# Video Products Technical Bulletin 30-2006-002

SUBJECT: **REUSE PARTS WHEN REPLACING BK BOARD**

MODEL: ***BVM-2012P***  
**BVM-2811**

**Figure 1**

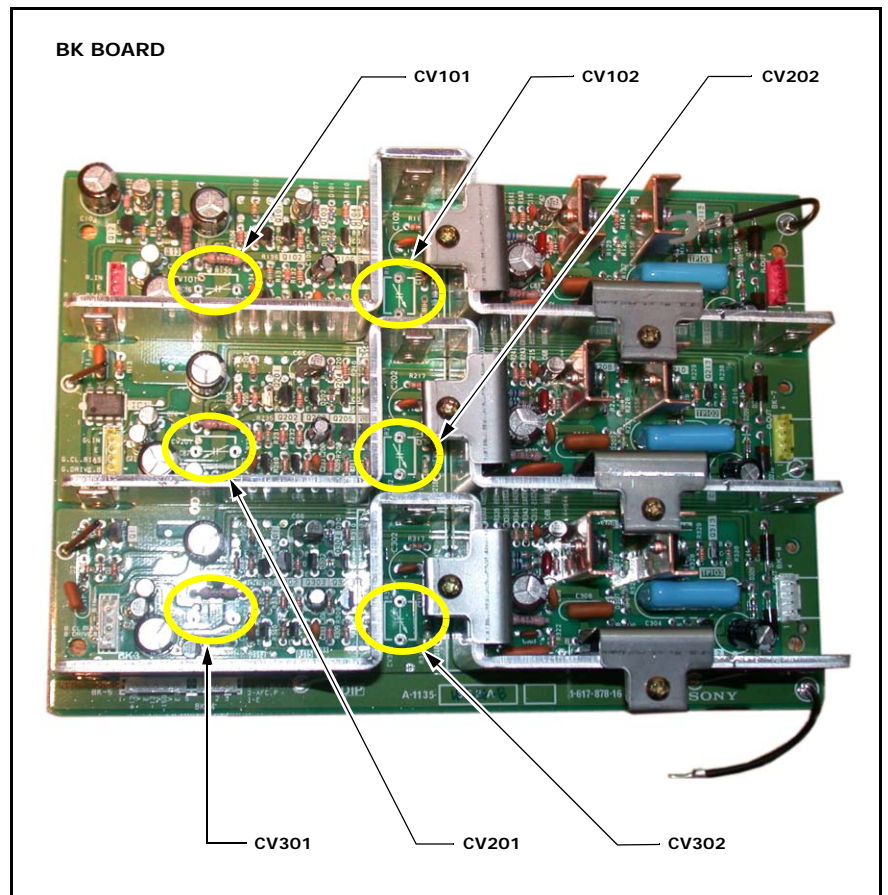
When you replace the BK board (A-1135-464-B), remove the following parts from the former board and install them on the new board.

Ref. No.	Description	Part No.
CV101, CV201, CV301	Single unit condenser 10PF	1-141-179-31
CV102, CV202, CV302	Single unit trimmer 15PF	1-141-180-13

The new BK board does not contain the parts, and the parts are no longer available. (See Figure 1.)
